## BCA COMPLIANCE ASSESSMENT – GEEBUNG LODGE THREDBO

<b>To:</b>	Geebung Lodge Thredbo	<b>Date:</b>	29 September 2023
<b>Attention:</b>	Gemma Wawn	<b>Project Ref:</b>	3025
<b>From:</b>	James Alexander	<b>Revision:</b>	Rev A
<b>Project:</b>	Upgrades to Geebung Lodge Thredbo		
<b>Purpose:</b>	BCA Compliance Assessment of existing ski lodge for DA submission.

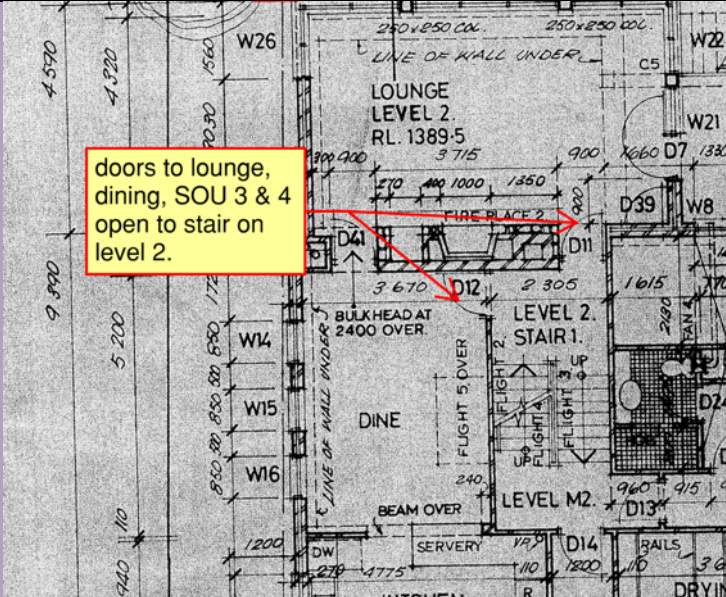
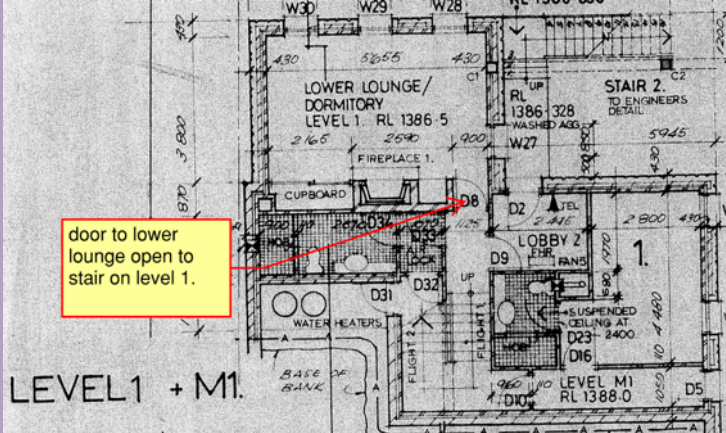
<b>BCA CLAUSE C3D7 - VERTICAL SEPARATION OF OPENINGS IN EXTERNAL WALLS</b>	<p>Spandrel separation is compliant.</p>	<p>Complies. The living room windows can be replaced without causing a spandrel non-compliance.</p>
<b>BCA CLAUSE C4D3 – PROTECTION OF OPENINGS</b>	<p>If the distance between an opening and the fire-source feature to which it is exposed to is less than: 3m from a side or rear boundary of the allotment, 6m from the far boundary of a road, river, lake or the like adjoining the allotment, if not located in a storey at or near ground level or 6m from another building on the allotment that is not a Class 10.</p> <p>The external wall openings to the east and west boundaries are located at 2.3m from the side allotment boundaries and</p>	<p>Protection is required to all windows located on the east and west boundaries given they are the subject of the development works.</p> <p>A performance solution can be</p>

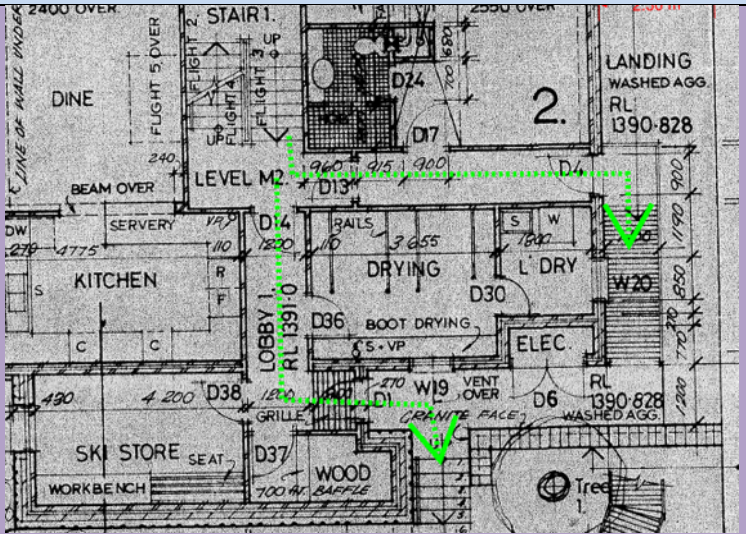
BCA CLAUSE	COMPLIANCE ISSUE	DESIGN RECOMMENDATION
	<p>therefore protection in accordance with this clause is required. Protection is not installed in accordance with C4D5.</p>  <p>Figure 5 – eastern elevation openings requiring protection</p>  <p>Figure 6 - western elevation openings requiring protection</p>	<p>prepared to permit a reduction in protection from that required by C4D5.</p>
<p><b>BCA CLAUSE C4D12 - BOUNDING CONSTRUCTION CLASS 2, 3 AND 4 BUILDINGS</b></p>	<p>The internal walls and floors and ceilings which form the bounding construction to the SOUs are generally Type A compliant given they are masonry.</p> <p>The bounding walls are load bearing and therefore required to achieve 90/90/90. The walls are single skin masonry and therefore may, depending upon the height achieve the FRL.</p> <p>The doors to the SOUs and other rooms in the bounding walls are required to be -/60/30 self closing fire doors.</p>	<p>The doors to the SOU's are tagged as being -/60/30 fire doors.</p> <p>The doors from the living room, dining room etc which open to the stair are not fire doors and therefore are required to be addressed via the fire engineered performance solution.</p>
